CONTRACT CHANGE ORDER NO. ____
SHEET ____ OF ____

MARK	DATE	DESCRIPTIONS	BY	CH'D	CCO#
4	01/31/07	HINGE K PIPE BEAM BLOCKOUTS	MN	NV	15

SAN FRANCISCO OAKLAND BAY BRIDGE
EAST SPAN SEISMIC SAFETY PROJECT
SELF-ANCHORED SUSPENSION BRIDGE
(SUPERSTRUCTURE & TOWER)
HINGE K DETAILS NO. 2

SAN FRANCISCO OAKLAND BAY BRIDGE
EAST SPAN SEISMIC SAFETY PROJECT
YBI TRANSITION STRUCTURES - HINGE K
HINGE K CLOSURE DETAILS NO. 12

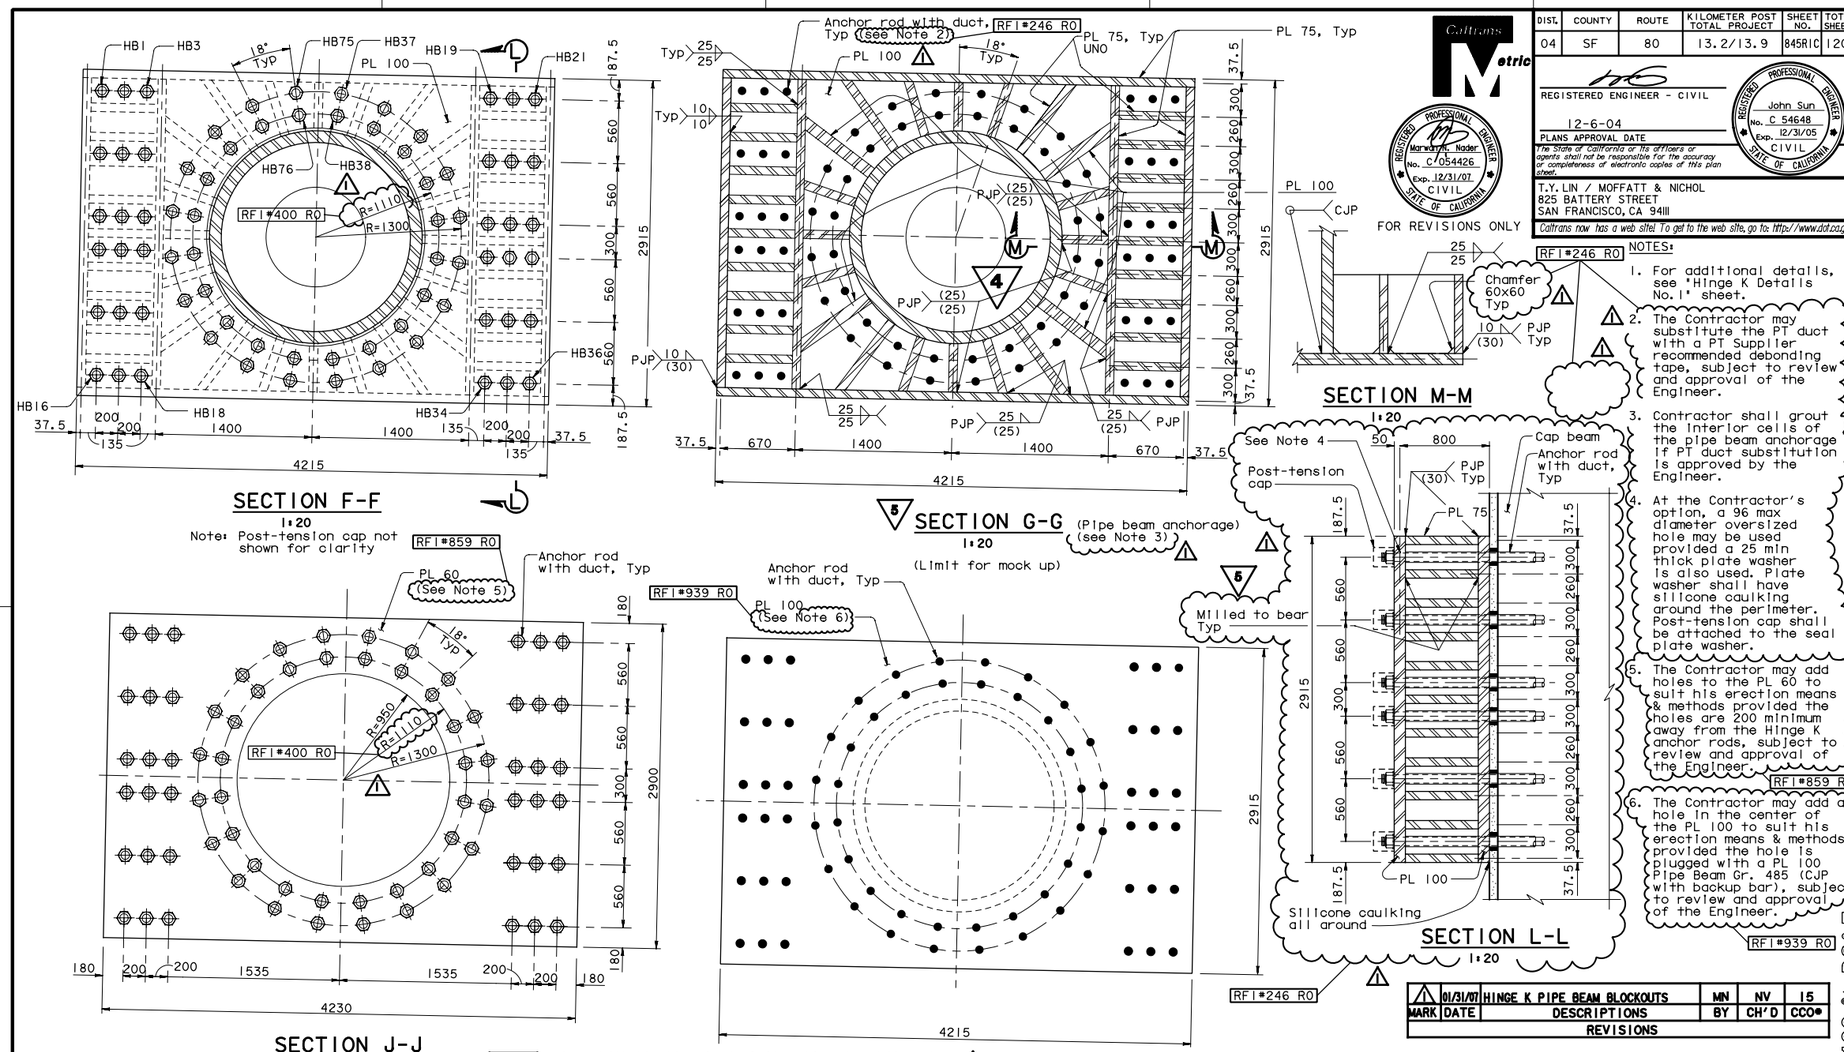
5. The Contractor may add holes to the PL 60 to suit his erection means & methods provided the holes are 200 minimum away from the Hinge K anchor rods, subject to review and approval of the Engineer. RFI #859 R0

6. The Contractor may add a hole in the center of the PL 100 to suit his erection means & methods provided the hole is plugged with a PL 100 Pipe Beam Gr. 485 (CJP with backup bar), subject to review and approval of the Engineer. RFI #939 R0
